## EAGLE MOUNTAIN PLANNING COMMISSION MEETING

**December 8, 2020, 5:30 PM**

| <b>TITLE:</b>     | PUBLIC HEARING - Scenic Mountain Phase C (Master Site Plan, Conditional Use Permit) |
| <b>ITEM TYPE:</b> | Master Site Plan and Conditional Use Permit                                         |

## 5 FIRE HYDRANT DETAIL

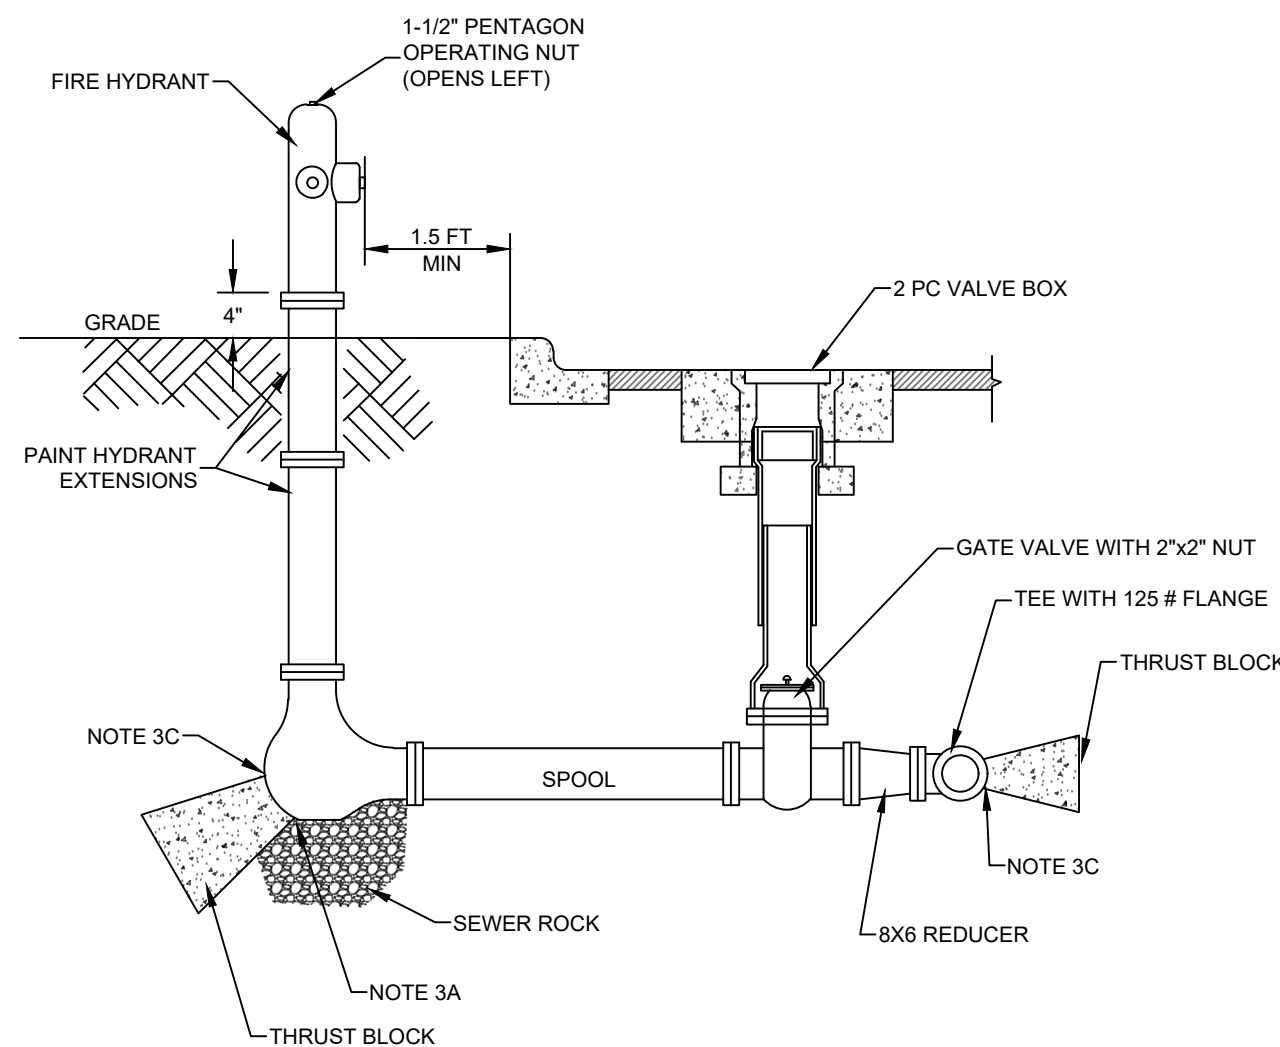
A fire hydrant is requested near unit #146. The fire hydrant detail (detail #5) in the master site plan packet should be updated to the city fire hydrant detail. All alleys need turn radius at the entry/exit points for fire apparatus.

4. "No parking" restriction for one side of any road under 32 feet in width;
5. Replace fire hydrant detail with city's fire hydrant detail;
6. All alleys need turn radius at the entry/exit points;
